SITE PLAN SUBMITTAL - HAC SCG DIV 48 BLDG S75

ADMINISTRATIVE AMDT. 4-22-87
REVISE DIMENSIONS OF PARKING LOT LIGHT
STANDARD CONCRETE BASE AND METAL
POLE LENGTH
2. REVISE MAXIMUM HEIGHT OF ROOF
SCREEN FROM 15' TO 12'
ADMIN AMDT 1986-6069-05 09-21-04
34. Extend screen wall around new chiller
ADMIN. AMDT 1986-6069-05 02-26-07
35. DELETE 2 PARKING SPACES & ADD SIDEWALK
TO NEW CROSSWALK

MINOR SITE PLAN AMENDMENT

RAYTHEON S75
INFRASTRUCTURE UPGRADES
16800 E. CENTRETECH PARKWAY
AURORA, CO 80011

SITE PLAN

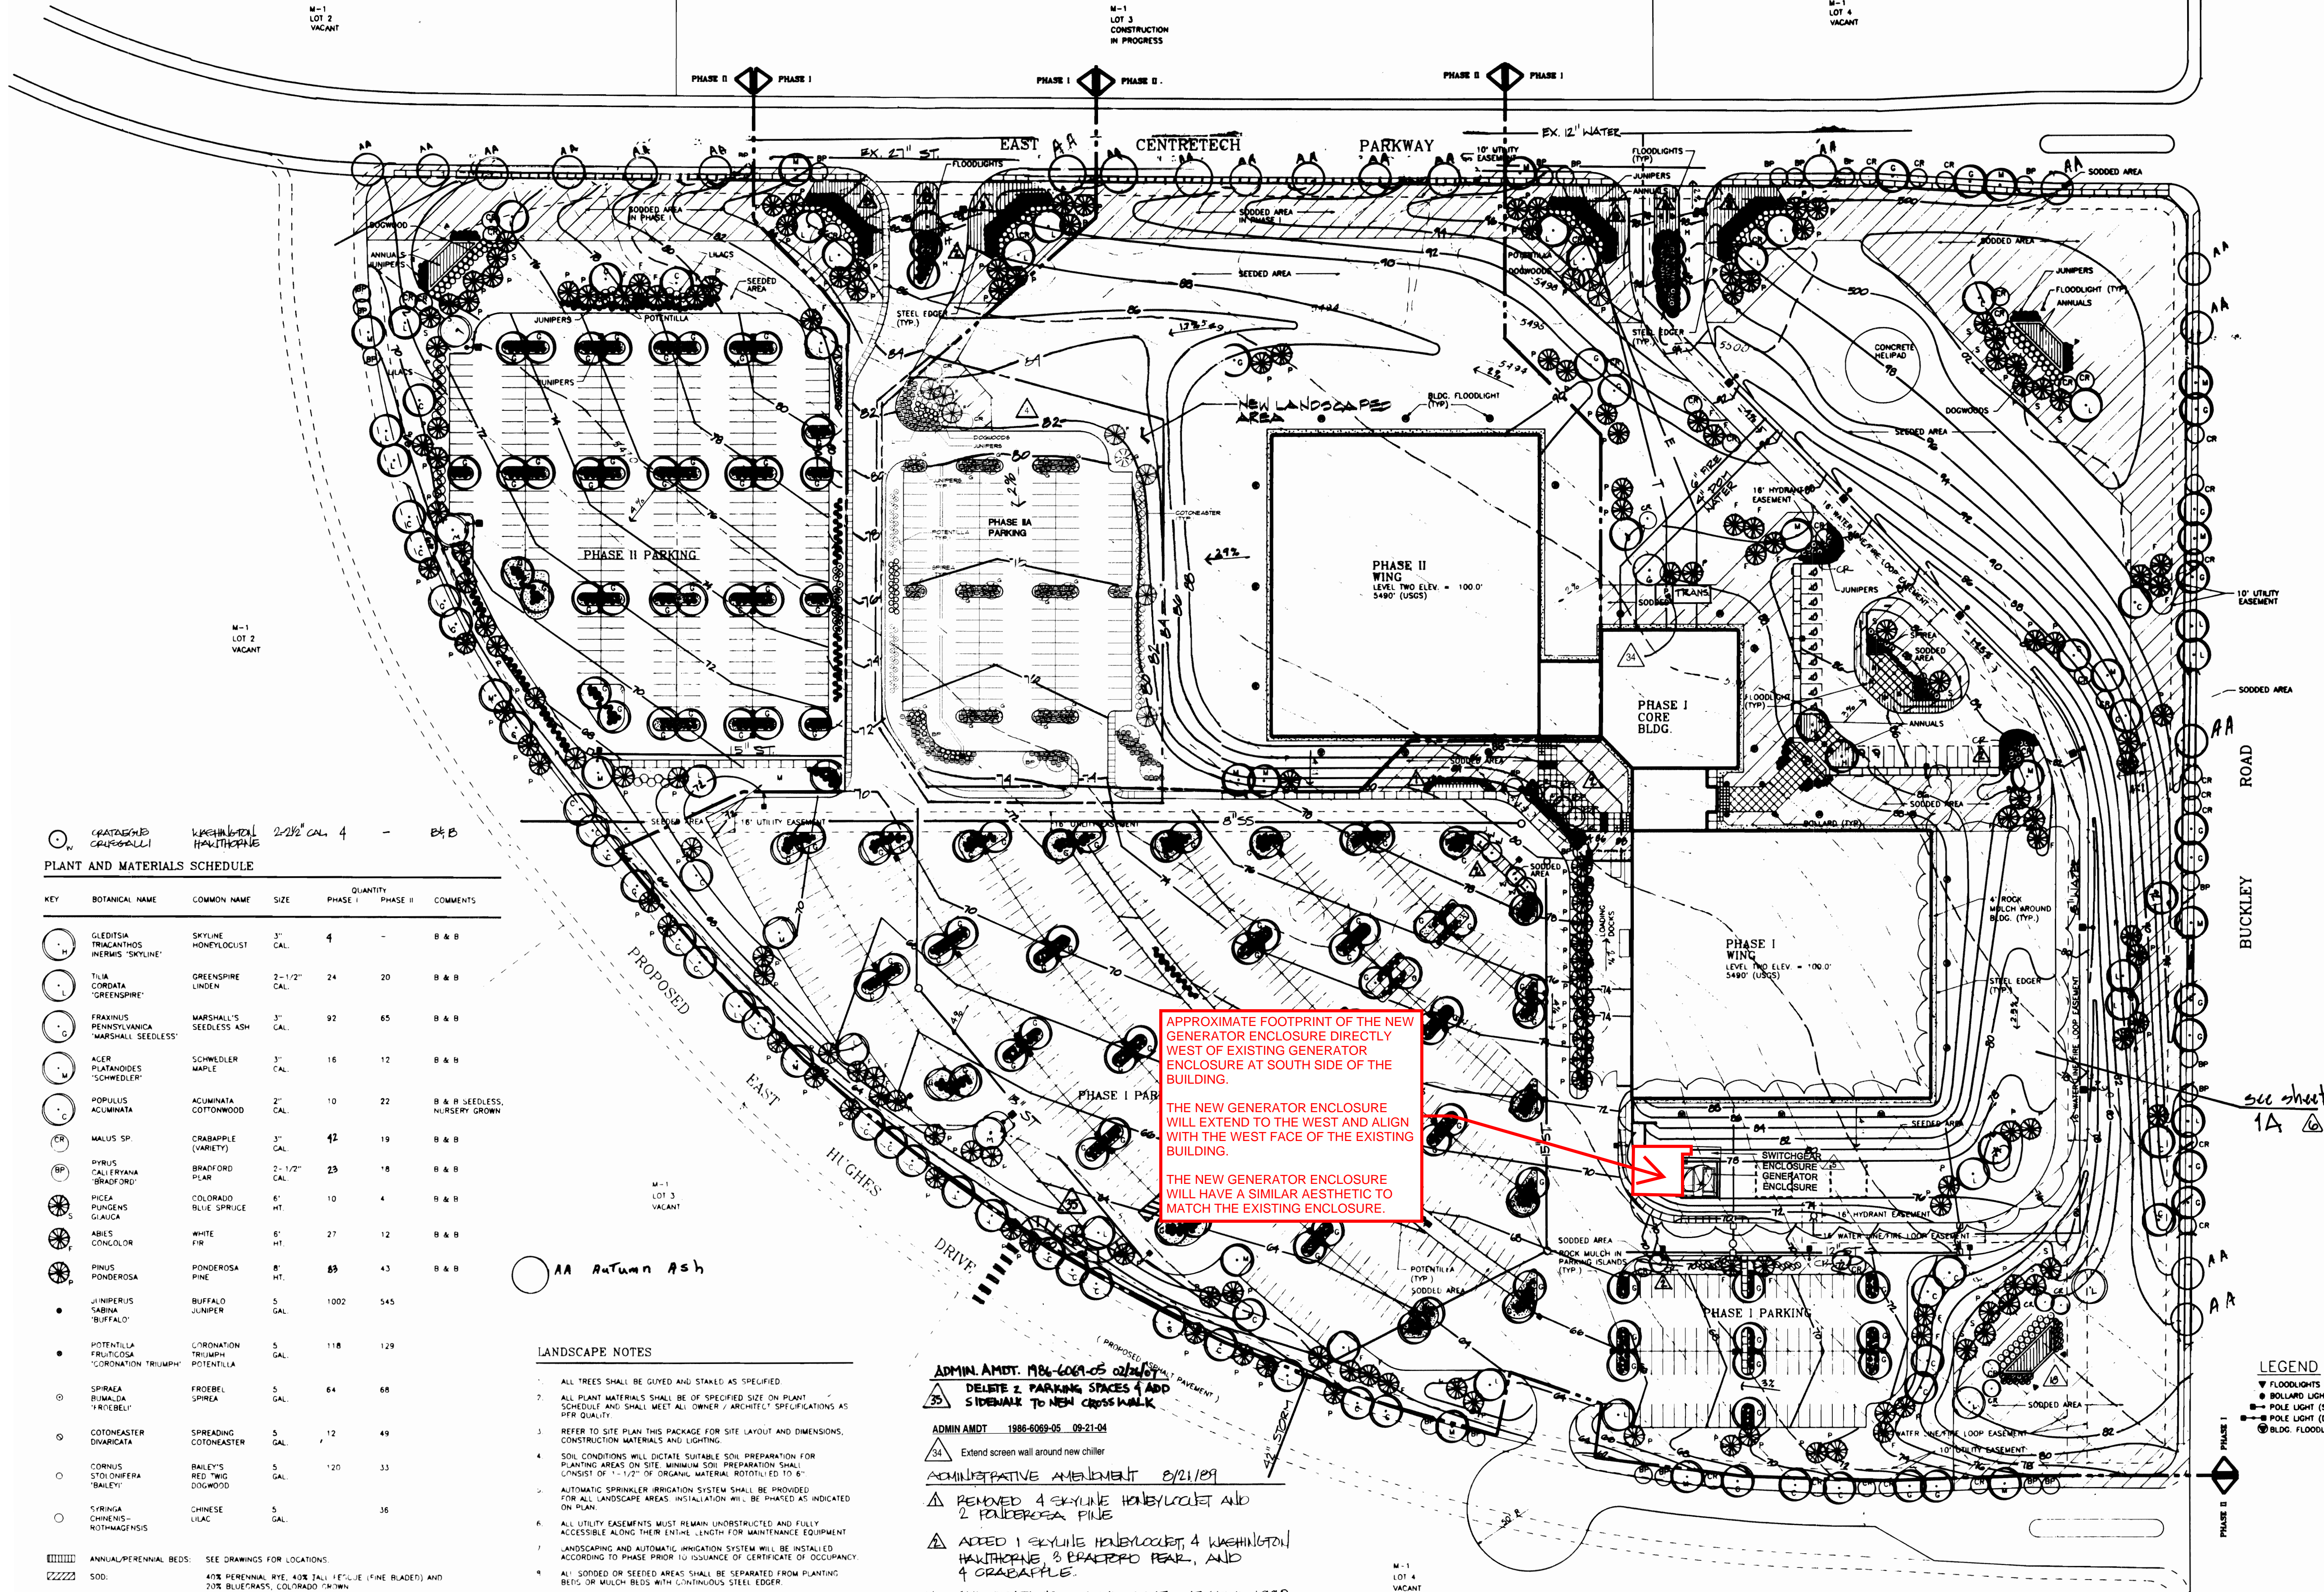
- REVISOR DIMENSIONS OF PARKING LOT LIGHT STANDARD CONCRETE BASE AND METAL POLE LENGTH
- REVISOR MAXIMUM HEIGHT OF ROOF SCREEN FROM 15' TO 12'
- RELOCATE/DELETE DRIVE AND PARKING LOT LIGHTING 6 SINGLE LUMINAIRE POLES DELETED 6 DOUBLE LUMINAIRE POLES DELETED

- RELOCATE 8" PUBLIC WATER LINE WITHIN 24' OF ACCESS DRIVE AND EASEMENT NORTH OF PHASE ONE CORE BUILDING
- DELETE 3" WATER METER AND 3" DOMESTIC WATER LINE TO PHASE TWO WING

- RELOCATE 6" FIRE LINE +/- 95' TO NORTH OF ORIGINAL LOCATION OFF 8" MAIN
- CHANGE 3" WATER METER AND 3" DOMESTIC LINE TO 4" METER & 4" DOMESTIC LINE AND LOCATE +/- 70' TO THE NORTH OF THE ORIGINAL LOCATION

- SHOW TELEPHONE AND PRIMARY ELECTRIC SERVICE LINES FROM EAST CENTRETECH PARKWAY TO THE PHASE ONE CORE BUILDING
- SHOW TRANSFORMER LOCATION NORTH OF THE PHASE ONE CORE BUILDING

- RELOCATE FIRE HYDRANT AND 16" EASEMENT +/- 25' TO THE NORTHWEST OF ORIGINAL LOCATION NORTH OF CORE BUILDING
- CHANGE THE PRIVATE STORM LINE NORTH OF THE PHASE ONE WING FROM 12" DIAMETER TO 8" DIAMETER AND REVISE CLEAN-OUT LOCATIONS ON EACH END OF THE LINE

- REVISOR LOCATIONS OF DROP INLETS M.H. AND 12" STORM LINE OFF SOUTHEAST CORNER OF PHASE ONE WING
- ADD M.H. AND REVISE LOCATION OF 12" PRIVATE STORM LINE FROM SOUTHEAST CORNER OF PHASE ONE WING TO REVISED DROP INLET LOCATION IN DRIVE SOUTH OF WING

- DELETE 12" STORM LINE AND M.H. PARALLEL TO THE SOUTH WALL OF THE PHASE ONE WING
- ADD NEW 6" STORM LINE FROM SOUTH WALL OF PHASE ONE WING TO REVISED DROP INLET LOCATION IN DRIVE SOUTH OF WING BUILDING

- DELETE M.H. & 12" STORM LINE AT SOUTHWEST CORNER OF PHASE ONE WING

- RELOCATE 8" PUBLIC WATER LINE WITHIN EASEMENT SOUTH & EAST OF WING BUILDING
- RELOCATE CORPORATE IDENTITY SIGN AND ASSOCIATED LIGHTING IN SOUTHEAST CORNER OF SITE

- REVISOR ALIGNMENT OF 24" PRIVATE STORMLINE SOUTHWEST OF PHASE ONE WING BUILDING
- REVISOR SIZE OF PRIVATE STORMLINE WEST OF PHASE ONE WING FROM 12" TO 15"

- REVISOR LOCATION OF SANITARY M.H. AND SERVICE CONNECTION WEST OF PHASE ONE CORE BUILDING, AND STUBOUT FOR FUTURE GROUND INTERCEPTOR AND DELETE NORTHWEST SANITARY SERVICE LINE TO CURB

- REVISOR LOCATIONS OF STORM M.H. AND SERVICE WEST OF PHASE ONE CORE BUILDING
- REVISOR STORM SEWER SYSTEM FROM THE PHASE TWO PARKING AREAS SOUTH AND EAST TO THE CROSSING OF PROPOSED EAST HUGHES DRIVE INCLUDING PIPE AND M.H. LOCATIONS AND PIPE SIZES

- RELOCATE PRIVATE UTILITY CROSSING FOR LANDSCAPE IRRIGATION LINE AND ELECTRIC +/- 20' WEST OF WHERE CURRENTLY SHOWN BETWEEN PHASE ONE & TWO PARKING AREAS

- ADD NEW M.H. IN EXISTING 27" STORM LINE ADJACENT TO DROP INLET AT WESTERLY DRIVE OFF CENTRETECH PARKWAY
- ADD PRIVATE UTILITY CROSSING FOR LANDSCAPE IRRIGATION LINE AND ELECTRIC AT EASTERLY DRIVE OFF CENTRETECH PARKWAY

- EXTEND SIDEWALK ALONG DRIVE SOUTH OF SATELLITE DISH ENCLOSURE AND ACROSS ISLANDS OF SOUTHWEST PARKING AREA
- EXTEND SIDEWALK ALONG DRIVE ADJACENT TO PHASE TWO PARKING AREA

- ADD PRIVACY PANELING ON TOP OF SCREEN WALL AT ORIGINAL MICROWAVE ENCLOSURE FOR GENERATOR ENCLOSURE
- ADD SWITCHGEAR ENCLOSURE ON THE NORTH SIDE OF ORIGINAL MICROWAVE ENCLOSURE FOR GENERATOR ENCLOSURE

APPROXIMATE FOOTPRINT OF THE NEW GENERATOR ENCLOSURE DIRECTLY WEST OF EXISTING GENERATOR ENCLOSURE AT SOUTH SIDE OF THE BUILDING.

THE NEW GENERATOR ENCLOSURE WILL EXTEND TO THE WEST AND ALIGN WITH THE WEST FACE OF THE EXISTING BUILDING.

THE NEW GENERATOR ENCLOSURE WILL HAVE A SIMILAR AESTHETIC TO MATCH THE EXISTING ENCLOSURE.

LANDSCAPE PLAN

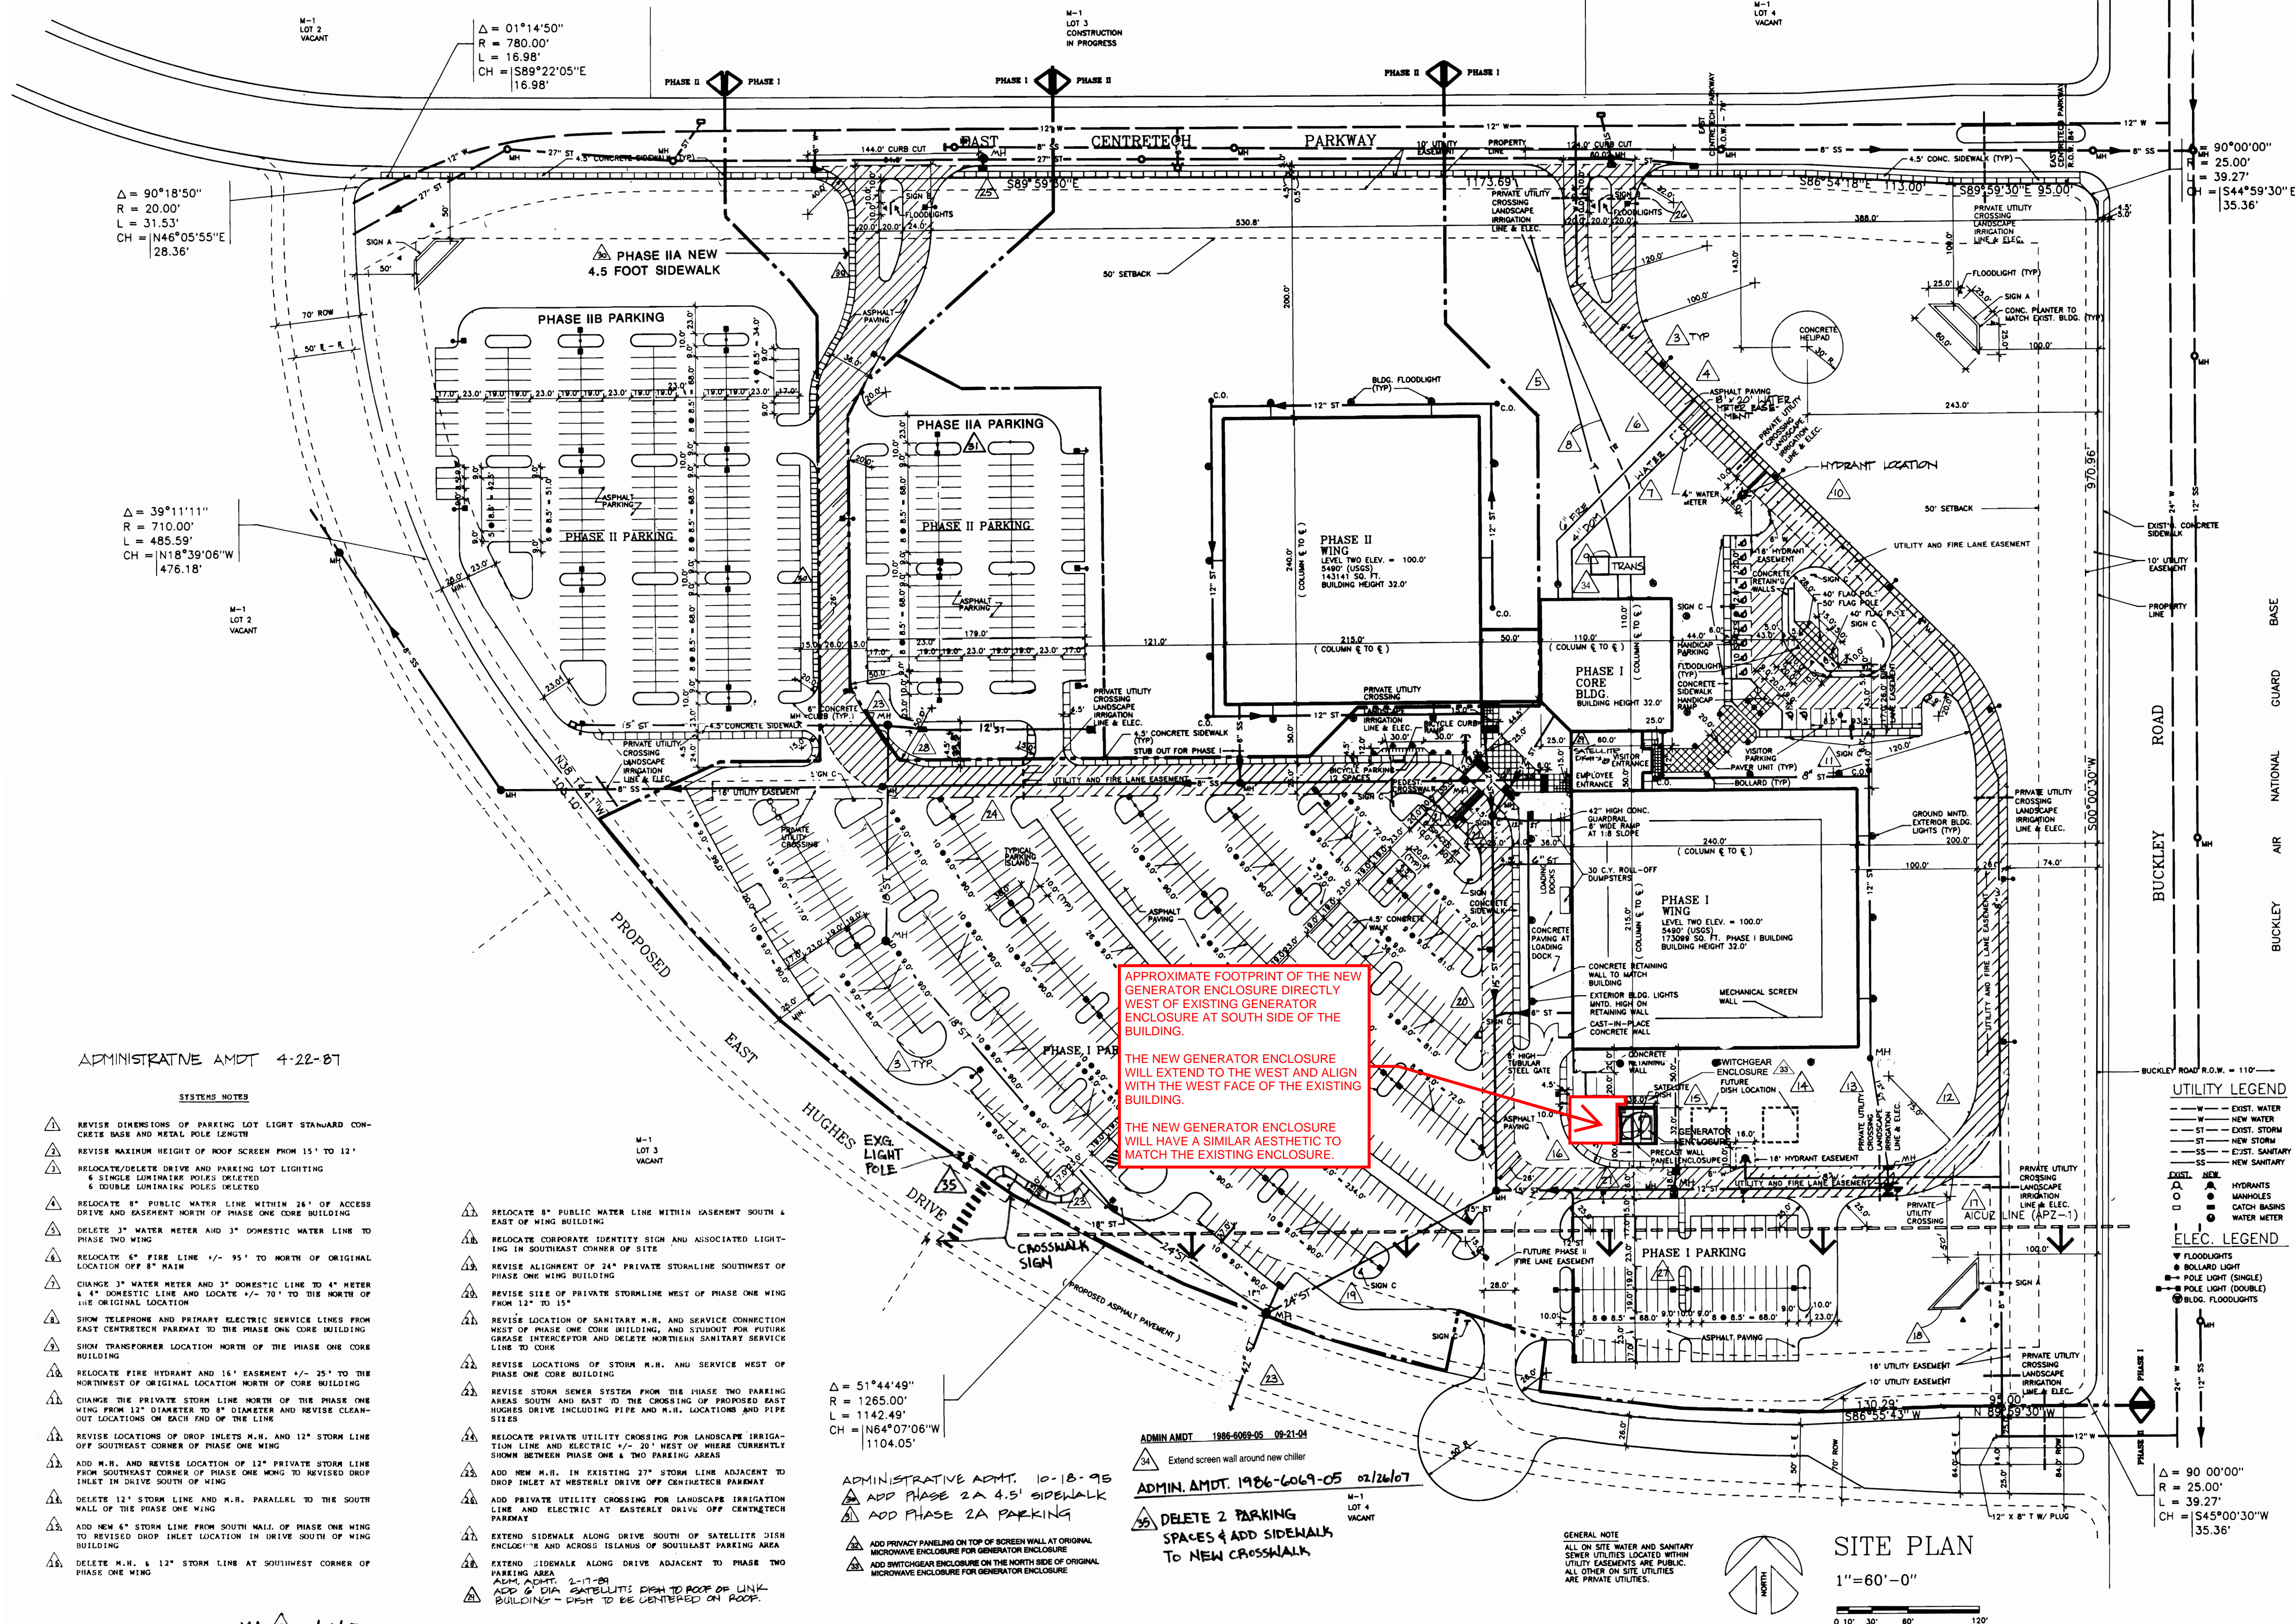
ADMIN. AMDT. 1986-6069-05 09-21-04
DELTE 2 PARKING SPACES & ADD SIDEWALK TO NEW CROSSWALK
ADMIN AMDT. 1986-6069-05 09-21-04
Extend screen wall around new chiller
ADMINISTRATIVE AMENDMENT 8/21/89
REMOVED 4 SKYLINE HONEYLOCUST AND 2 PONDEROSA PINE
ADDED 1 SKYLINE HONEYLOCUST, 4 WASHINGTON HAWTHORNE, 3 BRADFORD PEAR, AND 4 CRABAPPLE.
ADMINISTRATIVE AMENDMENT 17 APRIL 1990
ANNUAL FLOWER BEDS AT PROJECT ENTRY CORNERS & MEDIANS ADJACENT TO E. CENTRETECH PARKWAY TO BE REMOVED & REPLACED WITH SOD. AUTOMATIC IRRIGATION SYSTEM TO BE EXTENDED AS NECESSARY.
Administrative Amendment 04 November 2004
revised perimeter landscape (see sheet 1A)

ADMINISTRATIVE AMENDMENT 10-18-09
ADD PHASE II A LANDSCAPE AREA.
ADD SWITCHGEAR ENCLOSURE ON THE NORTH SIDE OF ORIGINAL MICROWAVE ENCLOSURE FOR GENERATOR ENCLOSURE
